415 LEGGET DRIVE STORMWATER MANAGEMENT REPORT

6TH SUBMISSION

Subject: Site Plan Control Application – 415 Legget Drive and 2700 Solandt Road – 4th Review Comments

Figure 2: 3-hour Chicago Design Storm Hyetographs - Ottawa

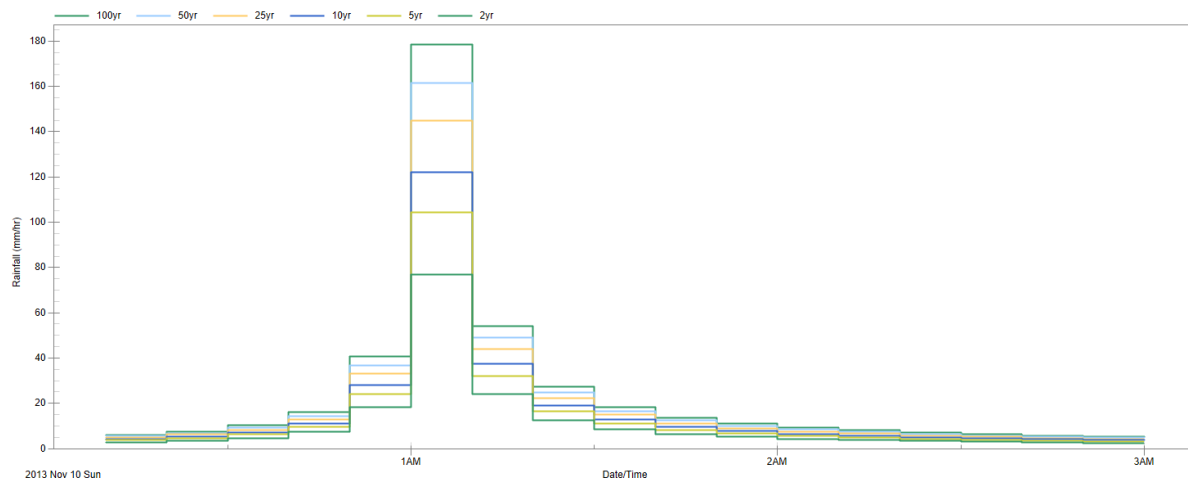
- 1.10. Initial Comment: Please provide tables all the rainfall hyetographs used.

Developer Response: The 3-hour Chicago design storm was used for each return period event. Hyetographs have been added to the report.

Figure 4: Proposed pond outlet structure

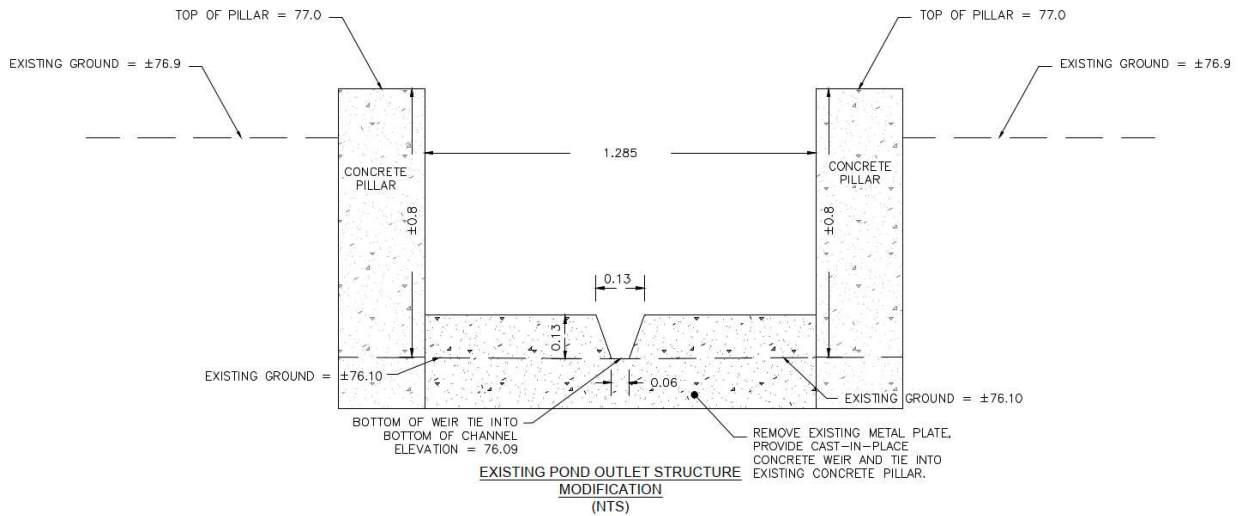
It would be helpful if table 7 also included the outflows. Please provide information on how the proposed v notch weir set at the channel bottom is modeled in PCSWMM. The invert of the weir is set at the channel bottom, and this will not be free flowing. With this new proposal to lower the outlet please provide information on the downstream channel and its possible effect on the outflow from the pond. There should be a channel segment added downstream of the pond outlet structure.

The change in the outlet will be include in the amendment to the ECA.
